TOWN OF WILTON
ADDENDUM NO. 2

RFP #2022-09

**Request for Proposal to Replace Lovers
Lane Bridge - Bridge #04975**

ADDENDUM NO. 2

ADDENDUM NO. 2
 DRAWING NO. S-09
 SHEET NO. 04.09.A2

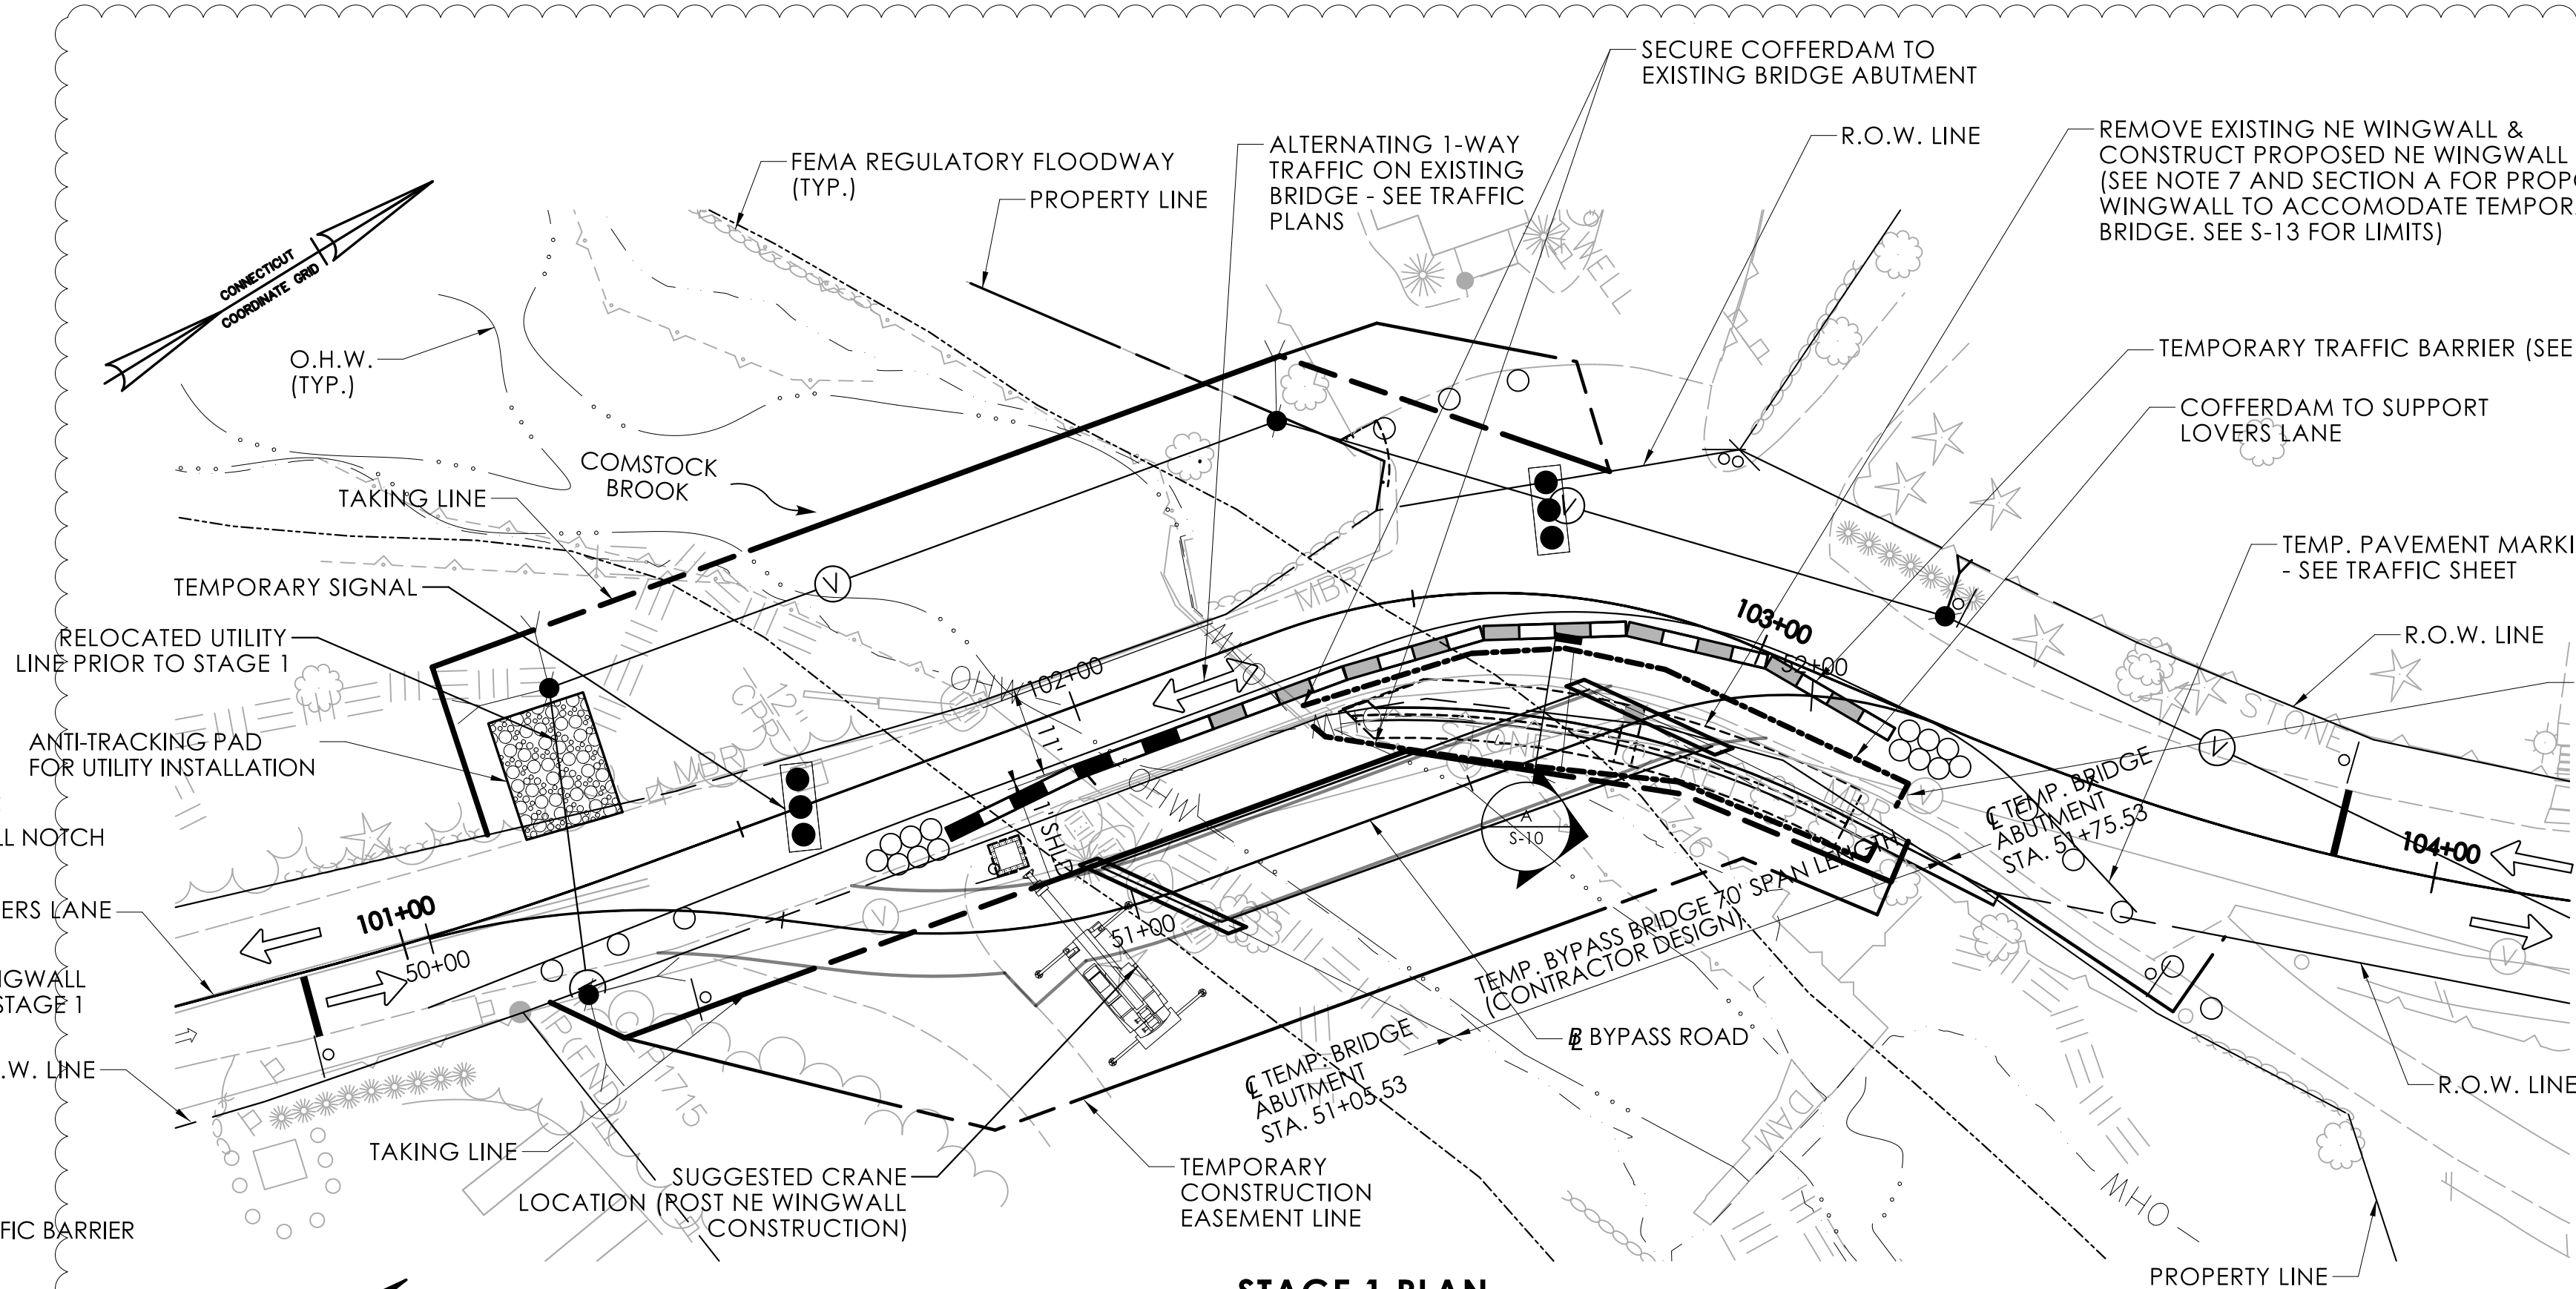
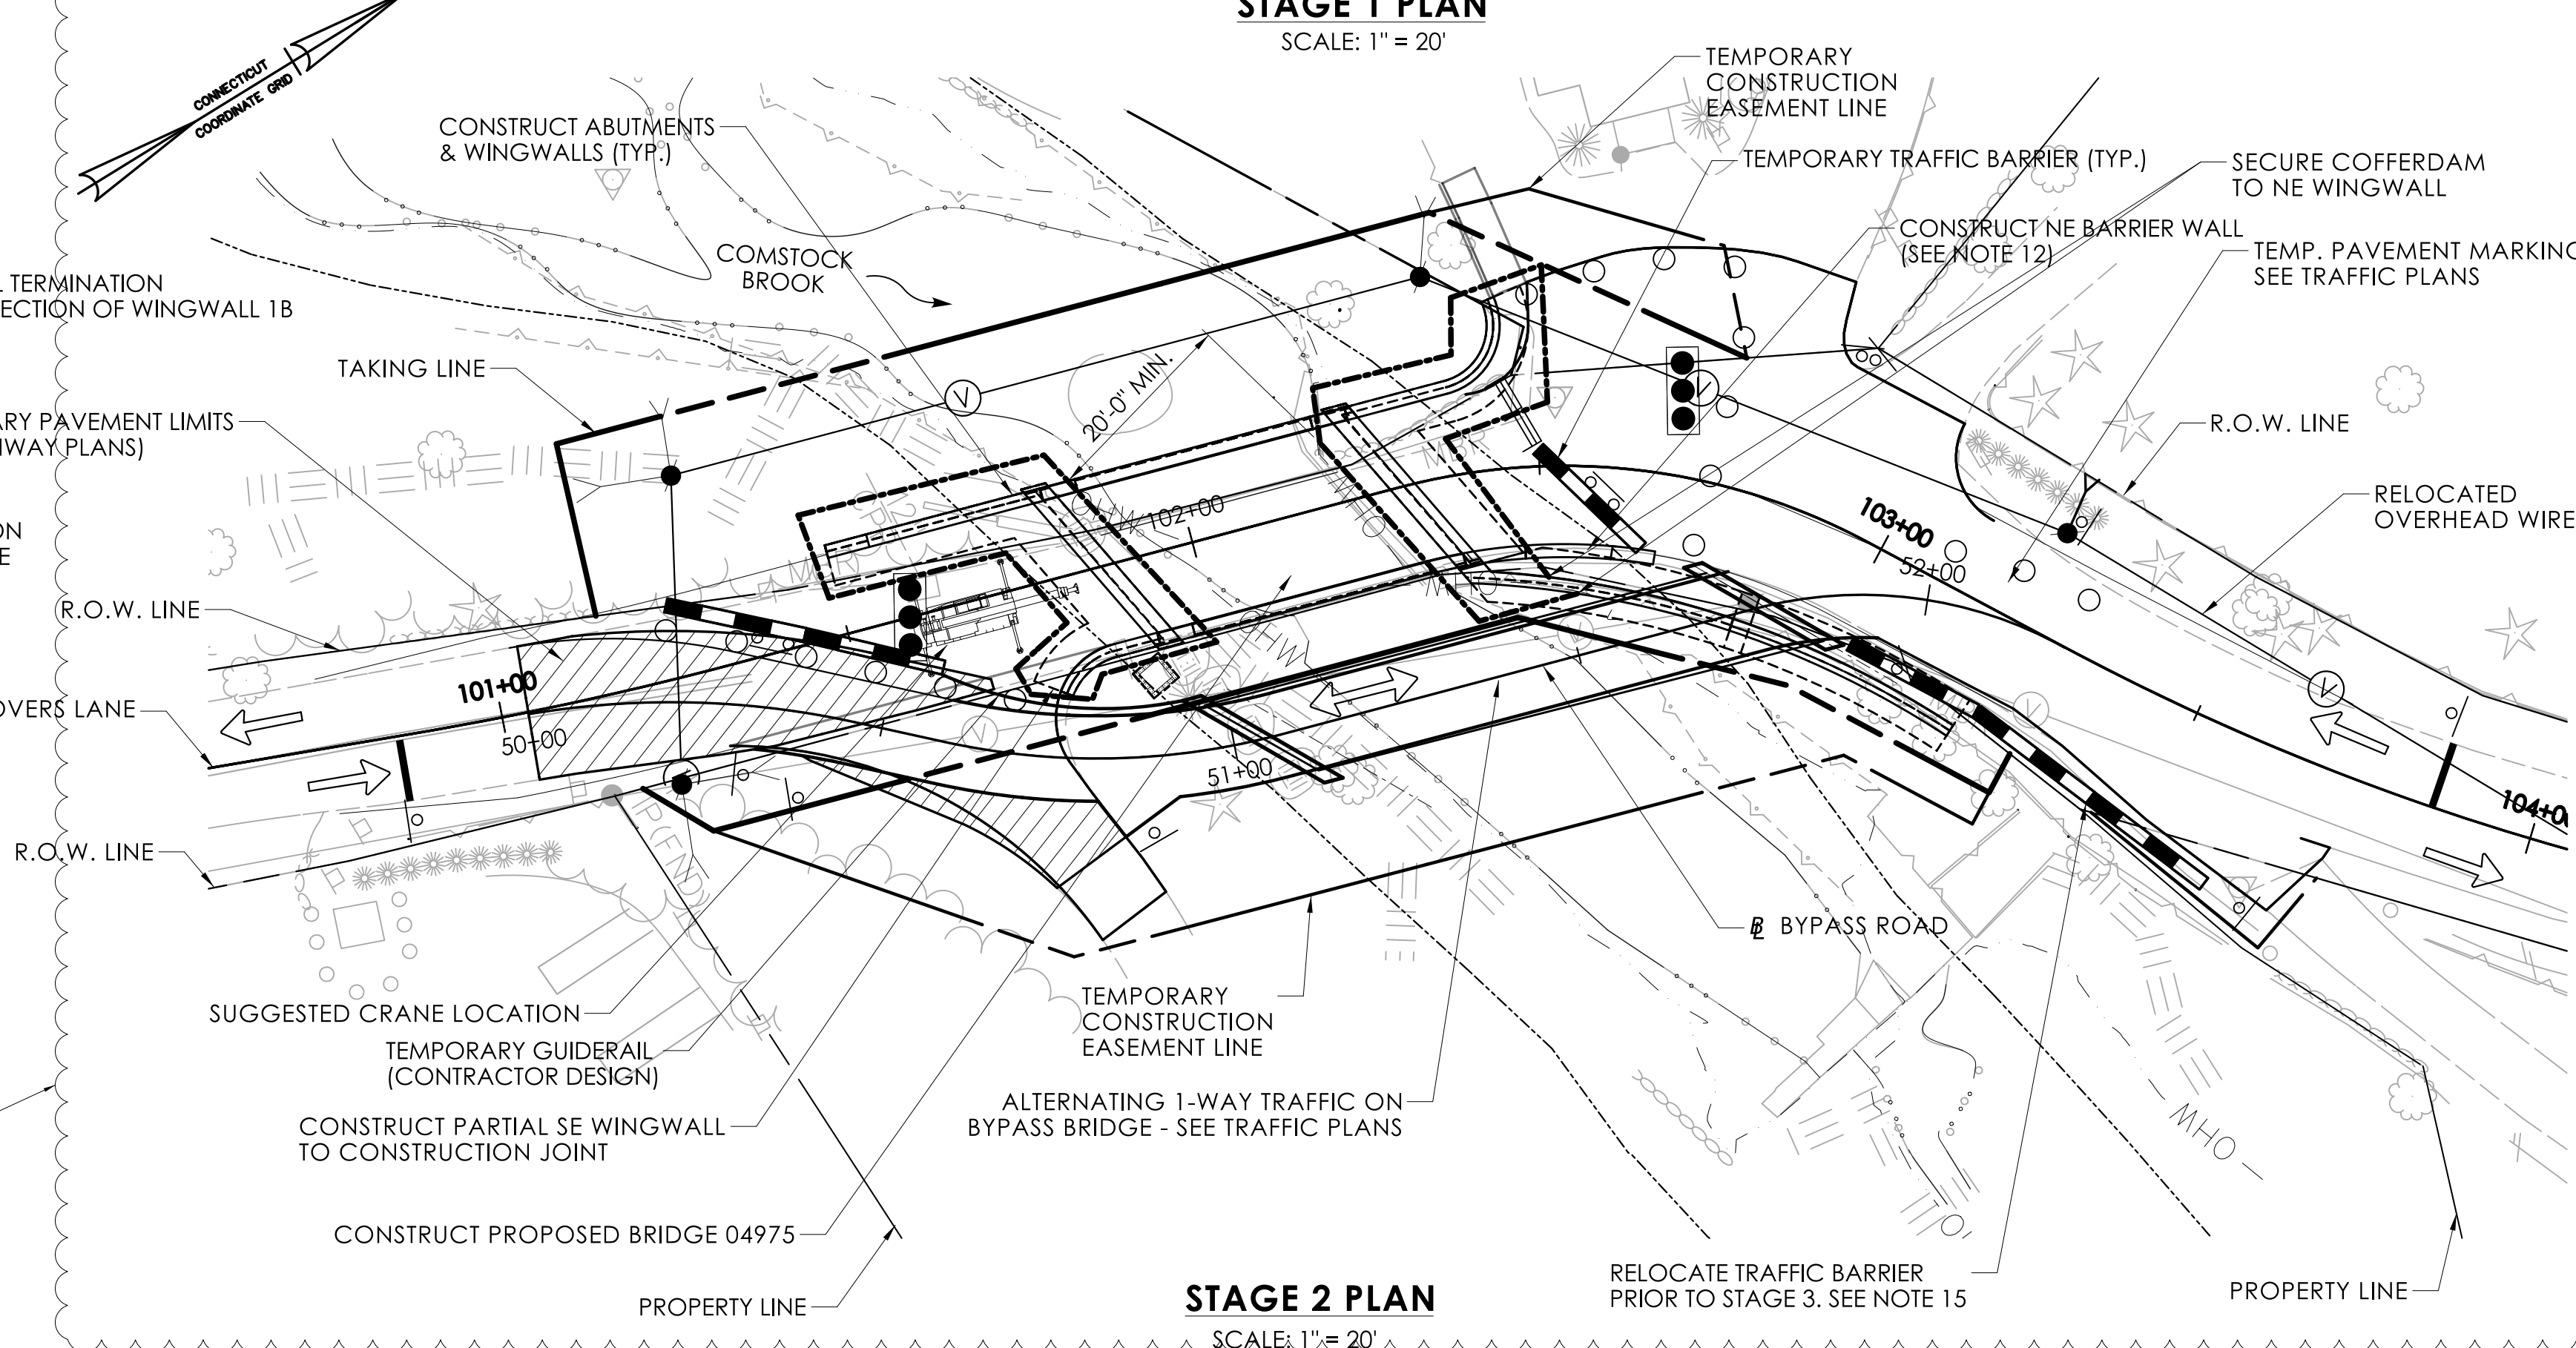
REV.	DATE	REVISION DESCRIPTION
1	12/15/22	REVISED STAGING PLAN
